Notice Type:	SAFE Notice		
Location:	Muswellbrook		
Subject Title:	Muswellbrook Permanent Speed Change		
Corridor/Line:	Hunte Valley	Direction:	Down Main
Control Board:	Upper Hunter 1		
Kilometrage:	286.504	To:	288.270
Effective From:	29/08/2025	Time:	0900 hrs

Amendments to Network Information Book:**OGW-30-17 – Singleton (exc) to Mt Pleasant (inc) & Aberdeen (exc)****Section 2.11 Grasstree**

Amendment to Route Access Standard:**H1 Islington – Muswellbrook****Section 4 Permanent Speed Restrictions**

DRIVERS DIAGRAM

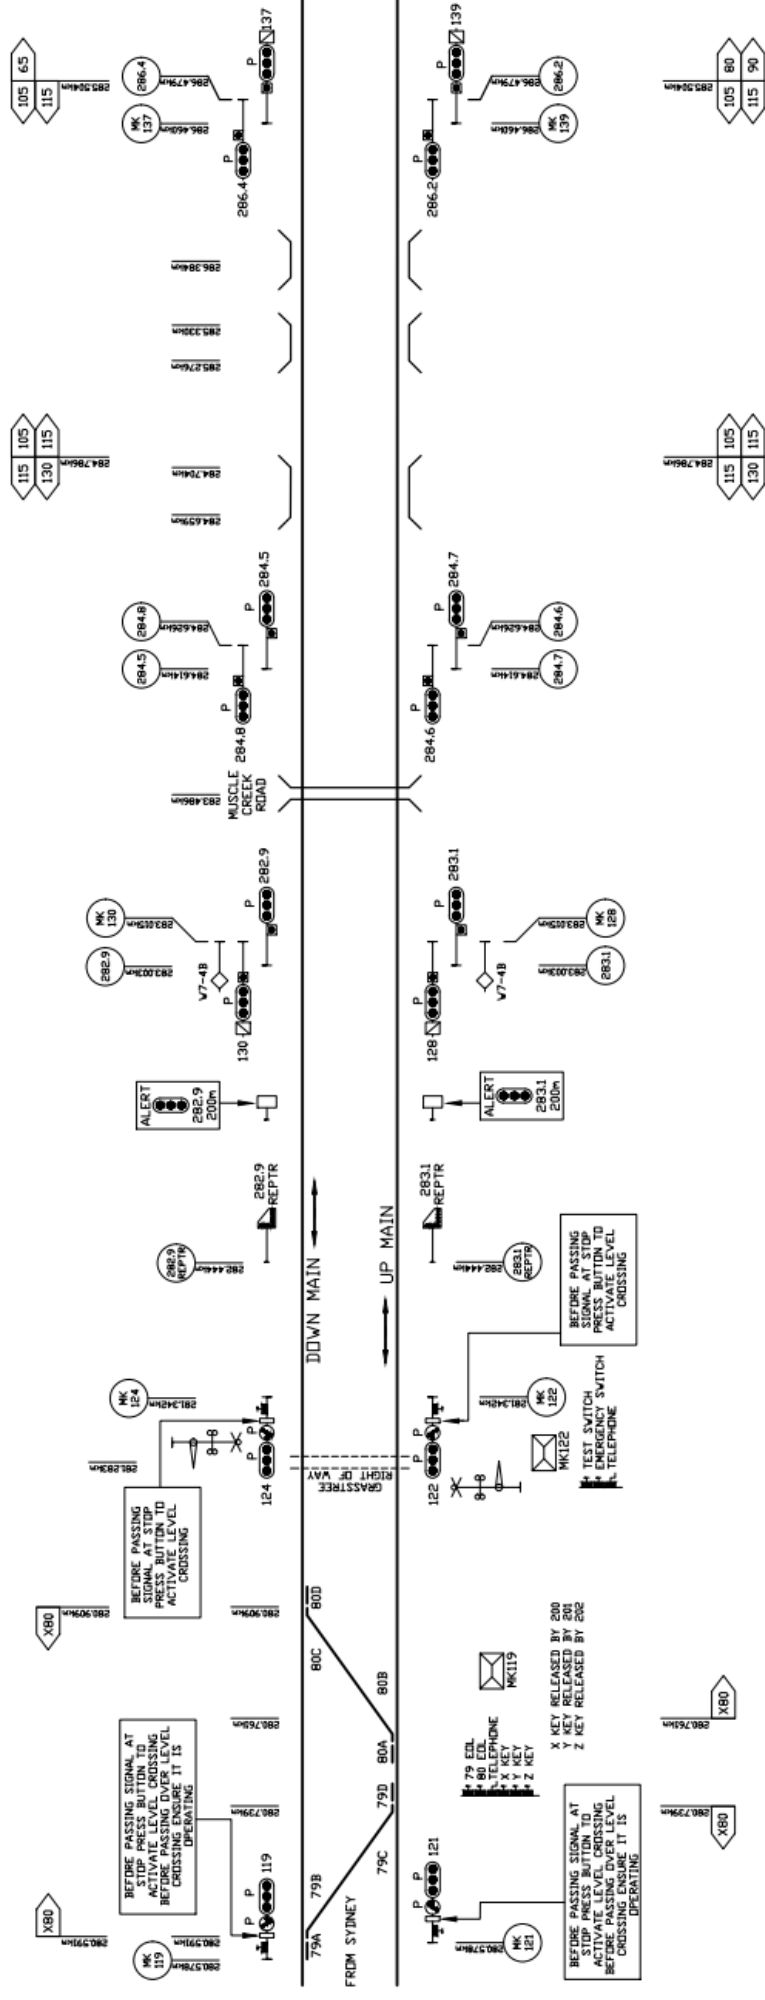
UPDATE: Diagram St Heliers NIB-T0568.

A copy of the Drivers Diagram for Grasstree and St Heliers is attached for further reference.

DELETE:	Location	Kilometrage	Down	
			Normal	Express
	Down Main	286.504	80	90
REPLACE WITH:	Location	Kilometrage	Down	
			Normal	Express
	Down Main	286.504	65	65
